HERNE HILL JUNCTION IMPROVEMENTS,
LONDON BOROUGH OF LAMBETH

Highway Works Appraisal

September 2008

IMA-08-088

- PLAN 1 -
MVA Option 2 Layout
Herne Hill Junction Improvement, Lambeth

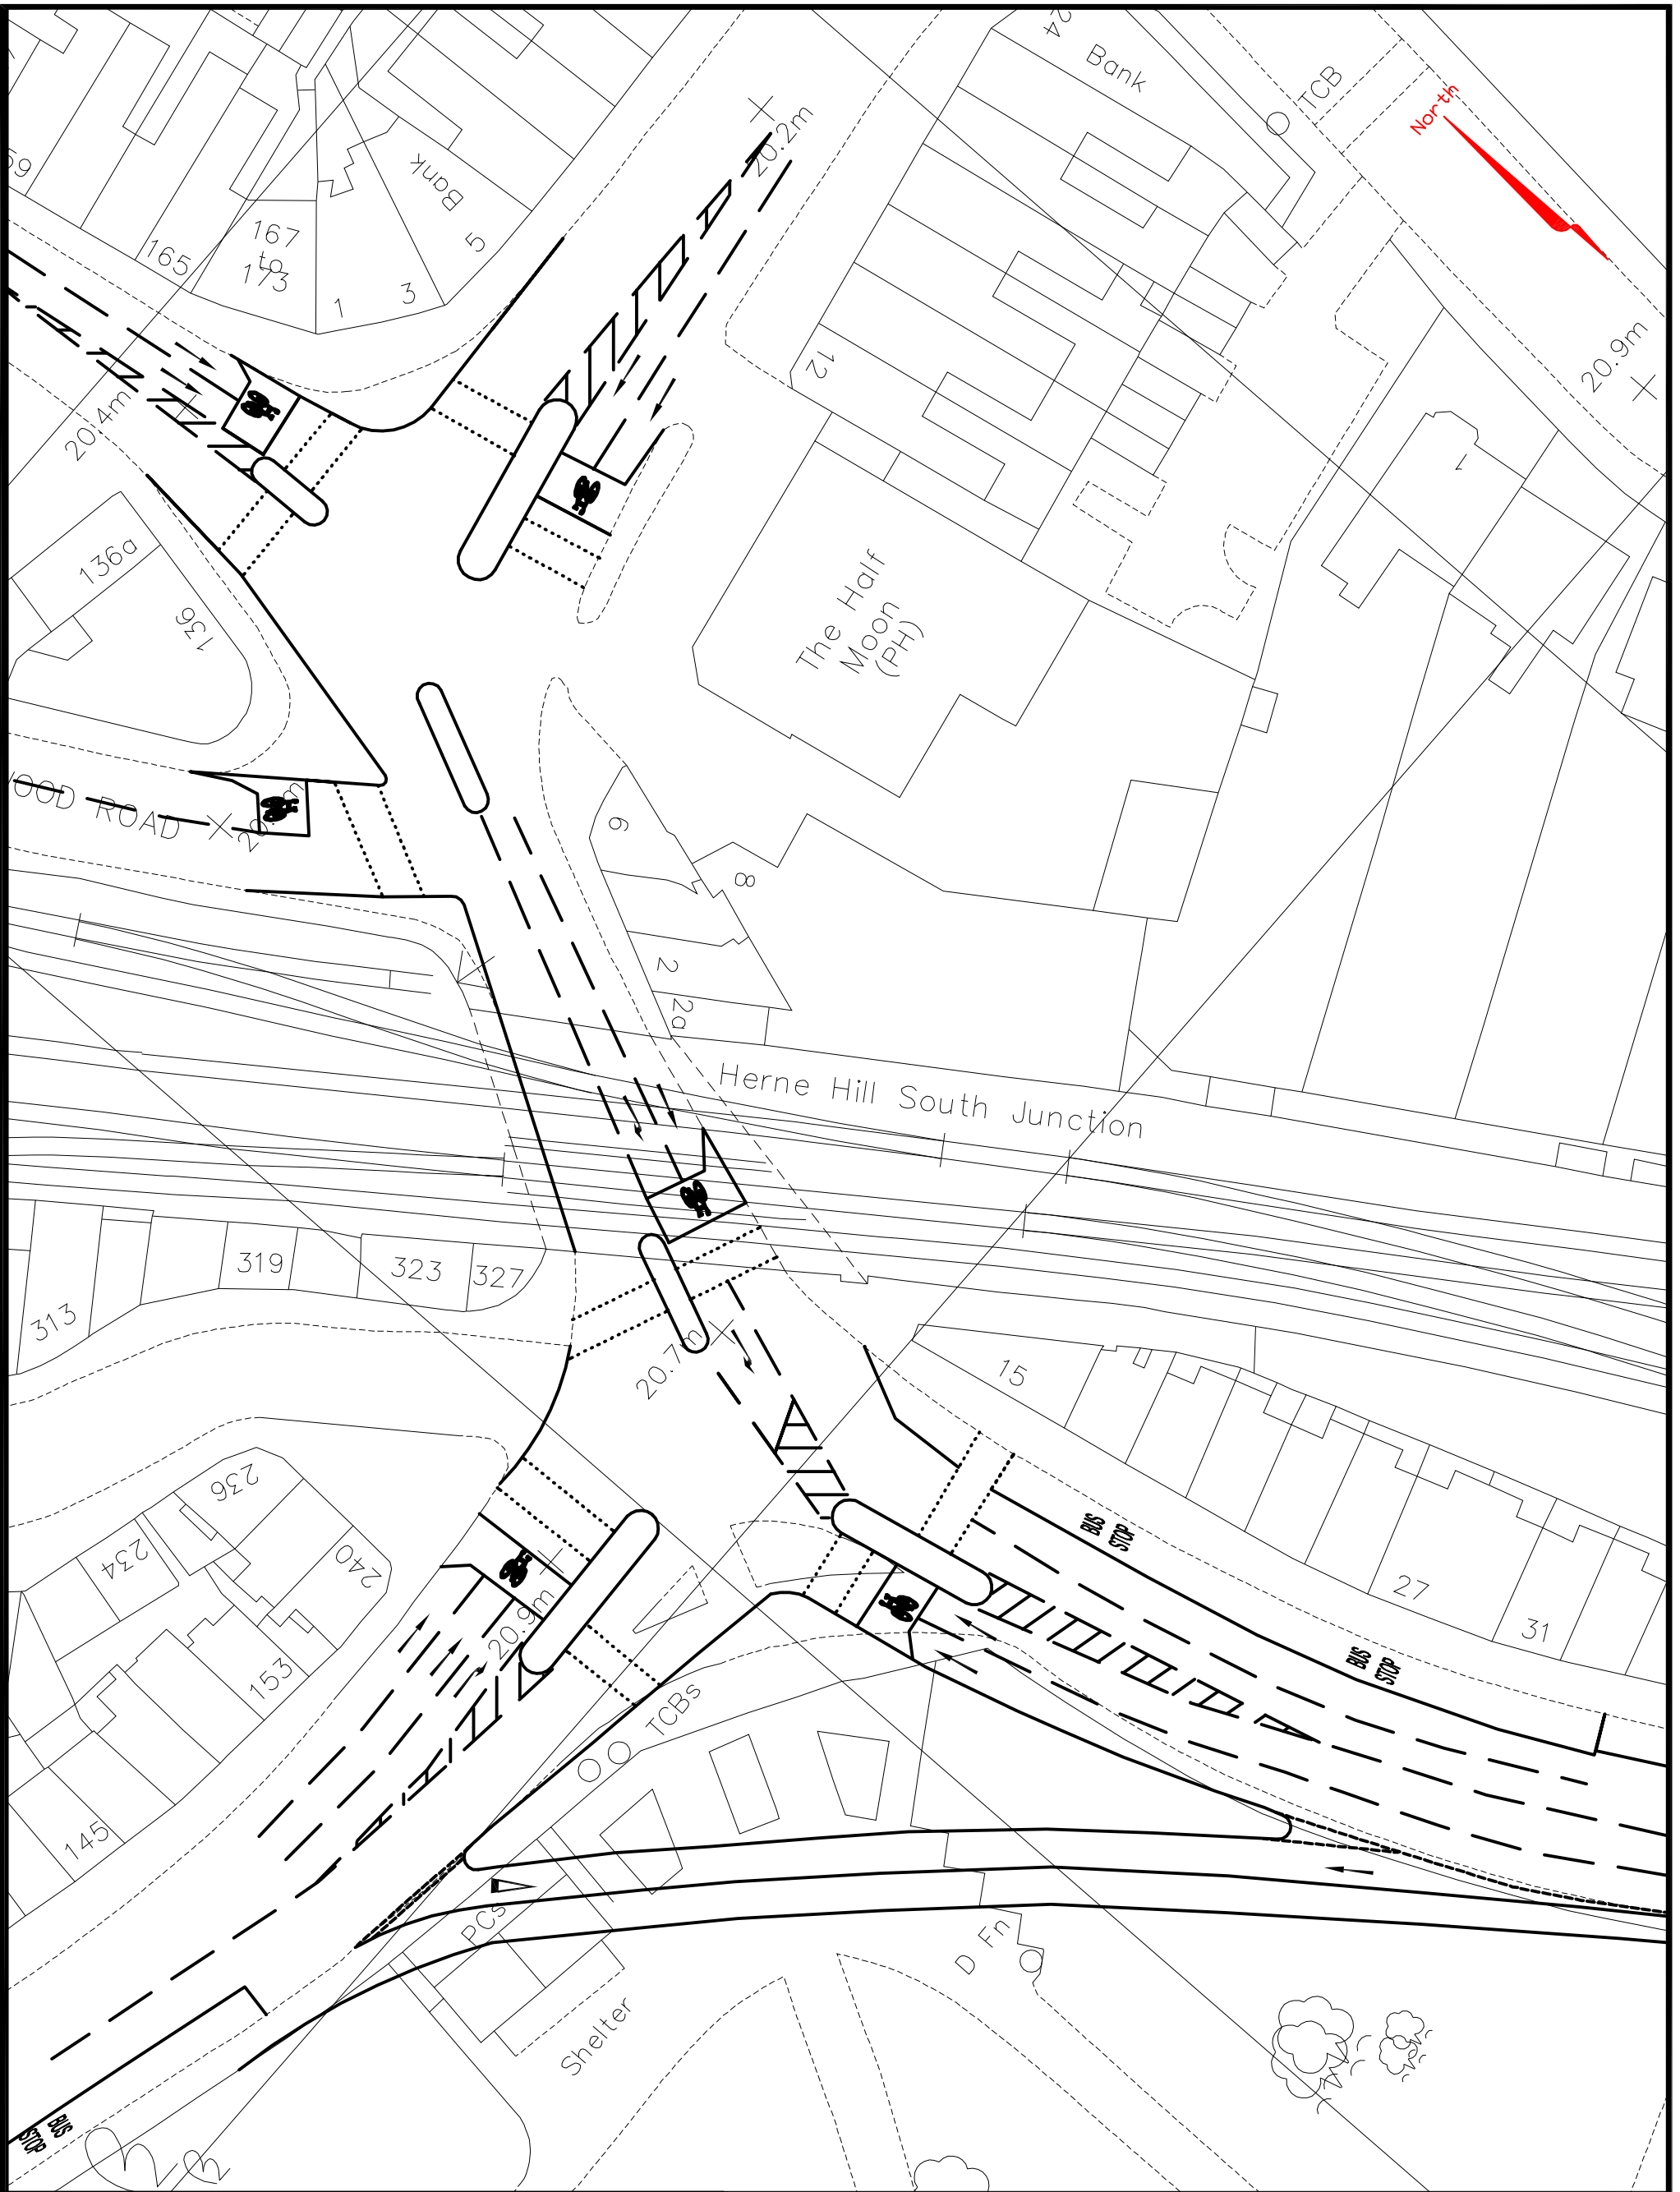
3.1.1 Consideration of the MVA scheme options has shown that Option 2 has been recommended over the less land-hungry Option 3 for 3 main reasons:

- (i) The desire to maintain a left turn lane from Norwood Road to Dulwich Road that is not obstructed by queues at the Norwood Road stop line.
- (ii) The need to stagger the Dulwich Road crossing to minimise impact on capacity.
- (iii) The need to have adequate space to 'land' pedestrians from the Dulwich Road crossing at the entrance to Brockwell Park.

3.1.2 The combination of the above factors has led MVA to a solution that involves pushing the highway boundary about 20m into the park, as shown in Plan 1. This results in a large triangular traffic island, with approximately 1,000m² of the park lost to highway land.

- PLAN 2 -
 IMA Alternative Layout
 Herne Hill Junction Improvement, Lambeth

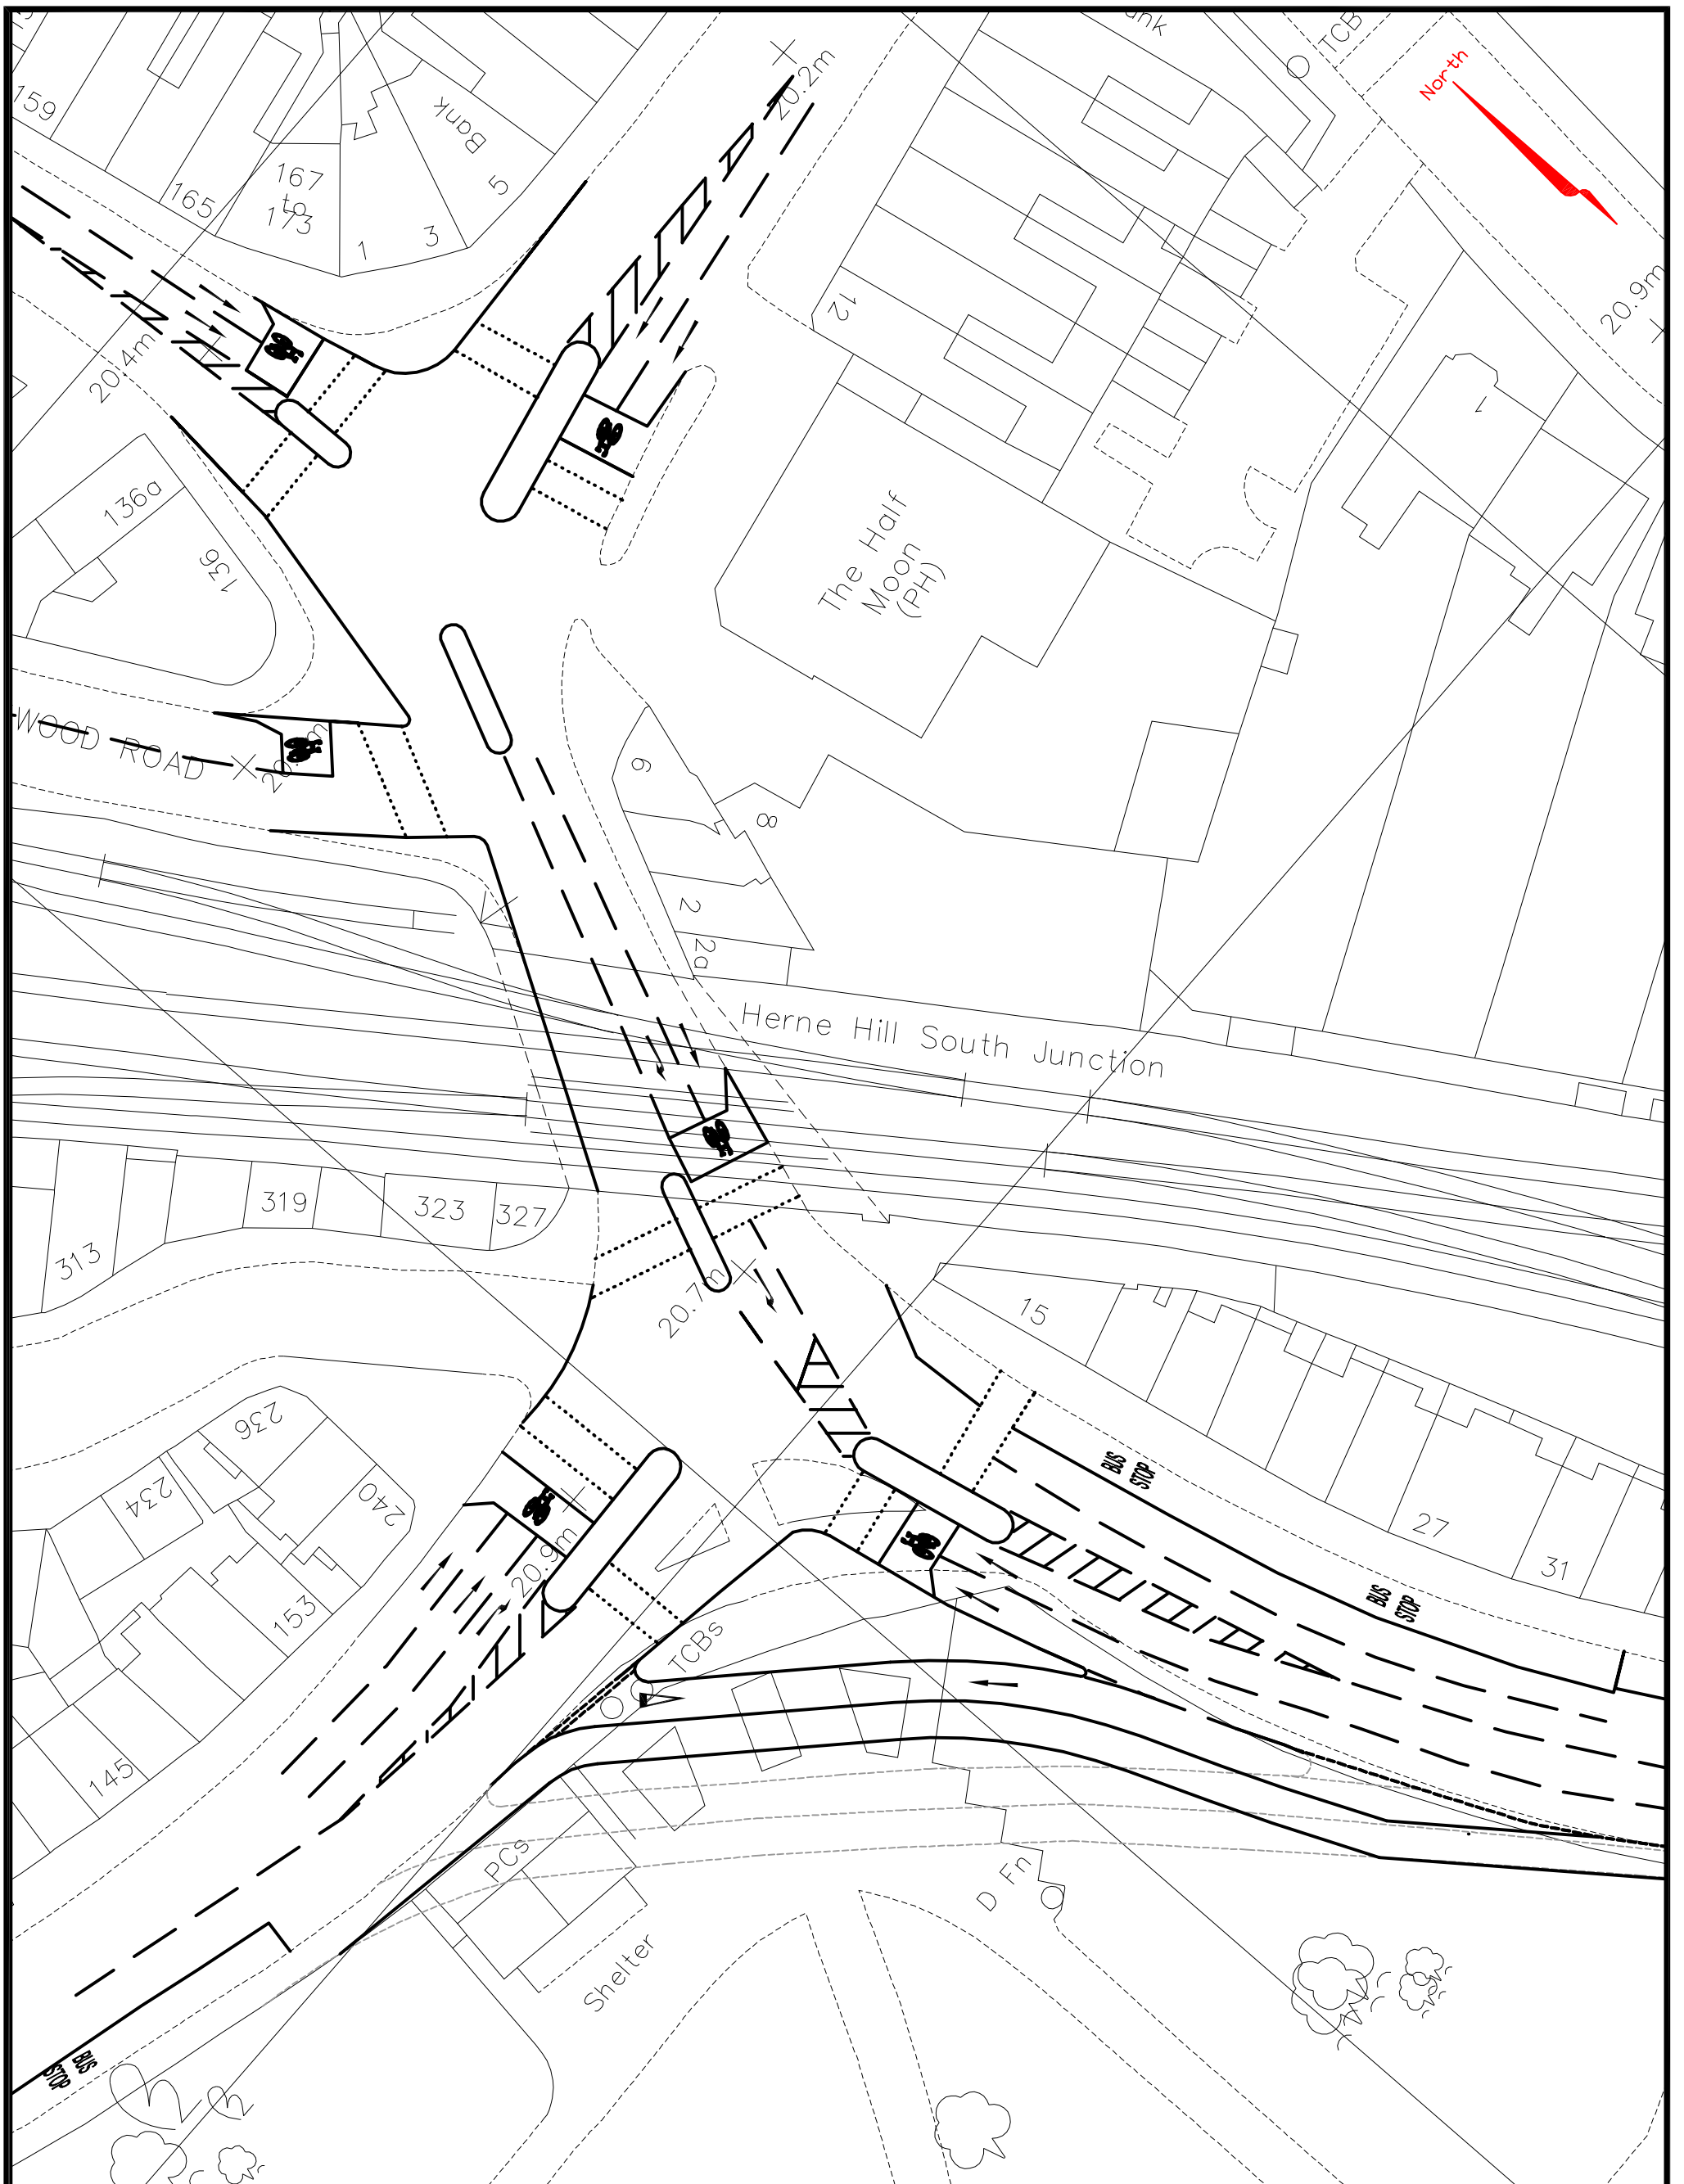
3.2.2 Plan 2 illustrates the alternative arrangement, which uses a much smaller traffic island and reduces land-take from the park by about 9m (the MVA Option 2 line of the slip road is shown in grey). The alternative arrangement meets all of the aims of the MVA scheme in exactly the same manner as their Option 2.

3.2.3 The alternative scheme maintains exactly the same clearance between the left-turn lane and the Norwood Road stop line as the MVA scheme (point (i) in section 3.1 above), retains the staggered crossing on Dulwich Road to maximise capacity (point (ii) above), and provides adequate space for pedestrians at the refuge at the park entrance (point (iii) above).

3.2.4 The alternative scheme effectively halves the impact on Brockwell Park while providing exactly the same benefits as MVA's preferred scheme, and it is recommended that this alternative arrangement is considered by the London Borough of Lambeth as a sensible compromise, derived entirely from Options 2 and 3 proposed by their own consultants, minimising impact on the park yet operating in exactly the same manner as the arrangement adopted by the council.
